# Final Decision

**File number(s):** CU 22-01 & DR 22-08

**Project name:** Woodburn Place West Apartments

**Date of decision:** September 8, 2022

*Exhibit CU2b (blue indicates extension of walkway poured concrete)*

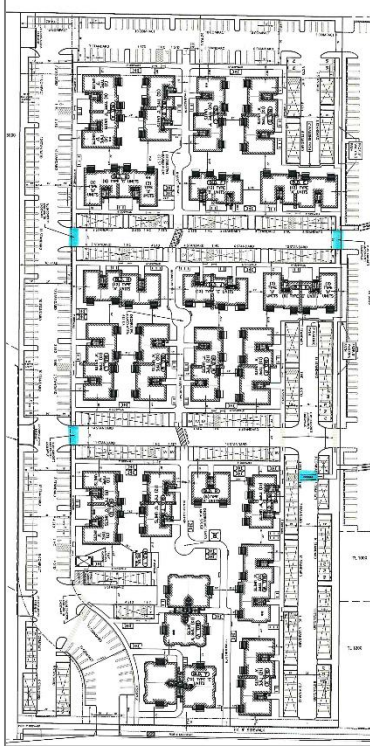
- b. Walkways: Per WDO 3.04.06d.2, applied such that per Exhibit CU2b below min 4 crossings shall be extension of walkway poured concrete:

Exhibit CU15a(3)

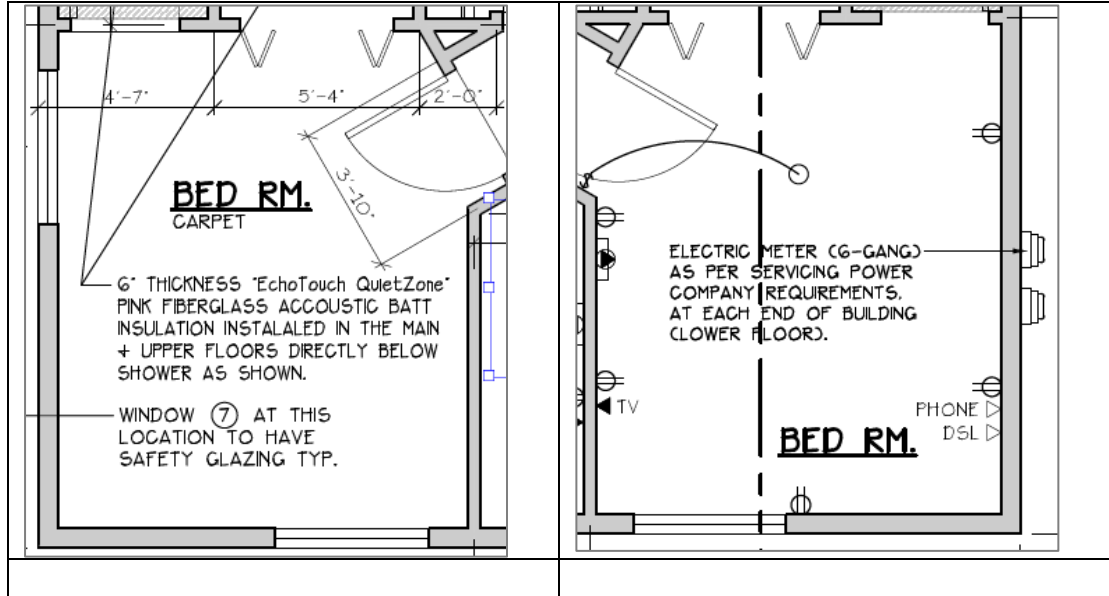
- (3) Per room: Within apts, every habitable room abutting a building exterior wall shall have min 1 window. Each ground floor corner room proposed through land use review to one on each elevation shall continue to have 2; however, where the developer to propose additional location(s) of exterior wall-mounted utilities and meters, then for each room, the second window may shrink to min 6 sq ft and be horizontally proportioned.

Exhibit CU15a(4)

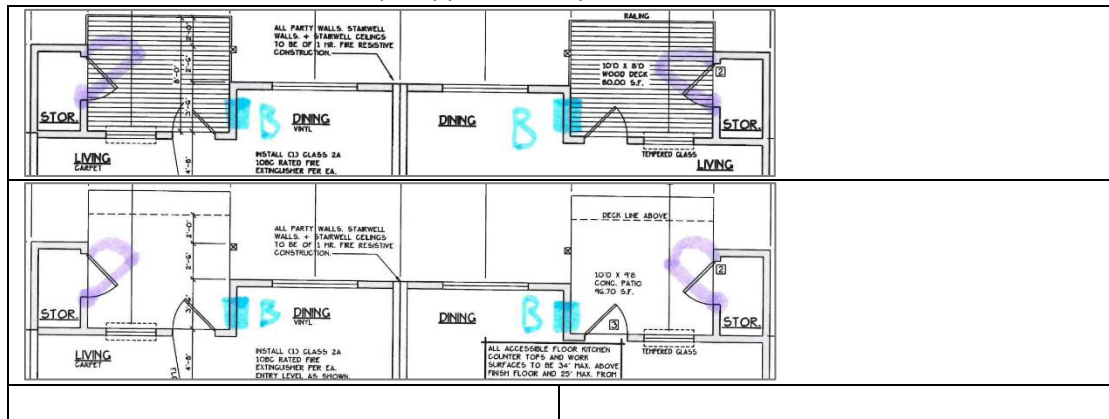
- (4) For units with floor plans resembling Exhibit CU15a(4) below with 3 ft or more off-set, each rear in the wall dividing dining/living area and patio or balcony shall have a window min width 1.5 ft and min area 7.5 sq ft approximately where the blue letter “B” indicates:

Exhibit CU21

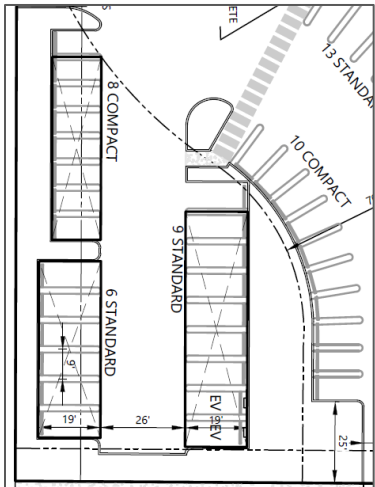
CU21. Carports in sewer forced main easement: Regarding the existing sewer forced main that runs north-south near the west lot line, the existing easement for it that runs along the west property line (County Reel 143, Page 1685, dated 1978), and the carports proposed within the south end of the easement, at the subject property SW corner, the developer shall do one of the following:

- a. Remove or relocate the proposed carports while maintaining conformance with WDO 3.05.03F.2, due by building permit application and with PW through this condition agreeing to the developer relocating carports into Street Corridor "C" near the southerly boundary, with a max of 4 stalls covered by carports, and avoiding conflict with public utilities;
- b. Through PW, rework a sewer forced main south segment to be east, sufficiently within and following a new proposed off-street PUE serving as Street Corridor "J", due the same as Condition G4; or
- c. Through PW, either obtain a revocable permit or enter into a written agreement, either legal instrument allowing for the carports to remain on terms set by PW, due by either when PW establishes or building permit issuance (of the structural permit for whatever is the first building or structure in the development), whichever is earlier.
